# SERVICE BULLETIN

IGNITION — PLUG, IGNITER — INTRODUCE A NEW IGNITER PLUG TO INCREASE DURABILITY

MODEL APPLICATION  
V2525-D5, V2528-D5

# V2500-ENG-74-0010

LOCATION OF THE IGNITER PLUG  
74-21-41  
FIGURE 1

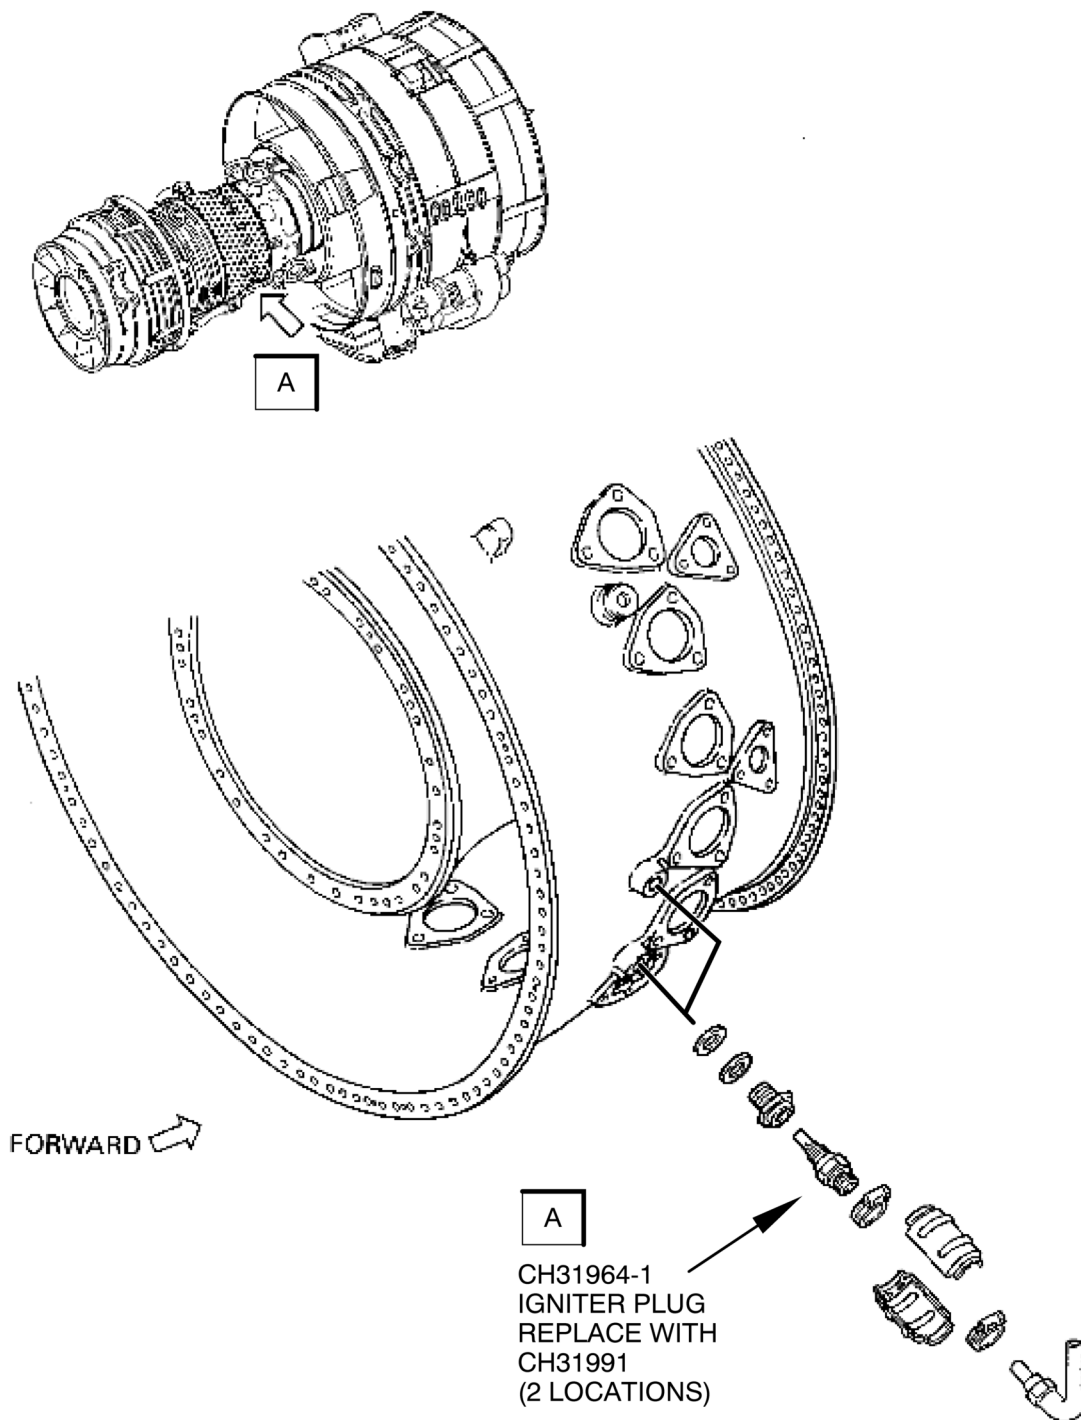
1. Replace the two Igniter Plugs, PN CH31964-1 with PN CH31991. See Figure 1.
  - A. Recording Instructions.
    - (1) A record of accomplishment is necessary.

IGNITER PLUG  
FIGURE 2

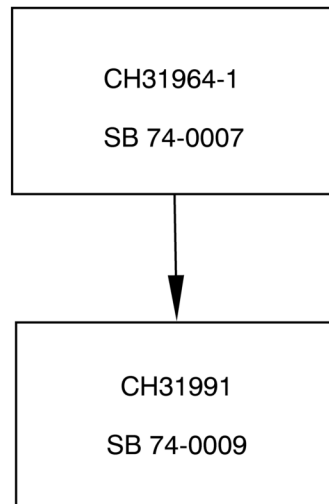
Parts Progression To Show the Changed Part in Relation to Other Parts
